AMENDMENT OF SOLICITATION/MODIFICATION OF CONTRACT	1. CONTRACT ID CODE	PAGE	OF PAGES
		1	7

7440851 Replace Chiller & Cooling Tower B4225, Station Marine Corps Air Station Cherry Point, NC

The purpose of this amendment is to answer pre-proposal inquiries (PPIs).

RFI Responses:

SCALE: AS NOTED
EPROJECT NO.: 7440851
CONSTR. CONTR. NO.
NAVFAC DRAWING NO. 12939367
SHEET 23 OF 39
M-702

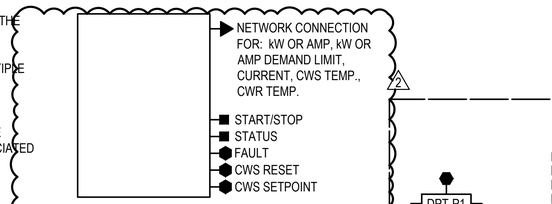
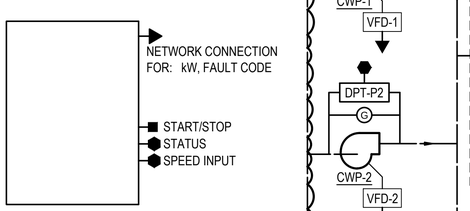
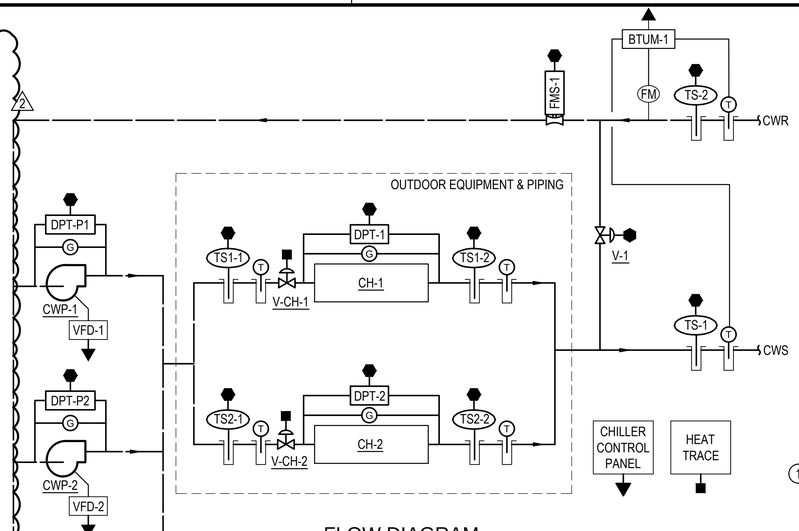
2. Chilled Water Control Points: M-702 shows several writeable outputs and control dependent inputs via network connection. This will not provide reliable control if network connection is lost. Revise all writeable outputs and the control dependent inputs to be hardwired to JCI Metasys controller

3. BTU Meter: M-702 shows a BTU meter being installed. For cost savings, the 2 temperature sensors and 1 flow meter shown on M-702 could be used to calculate BTU within JCI Metasys controller. Please confirm removal of BTU meter hardware.

Response: M-702 revised as requested. See attached updated M-702 drawing (NAVFAC # 12939367)

Response: Non-concur. TS-1 and TS-2 measure temperature out to system while FMS-1 measures plant flow on other side of bypass valve for ensuring chiller min flow is maintained. Provide BTU meter per drawings.
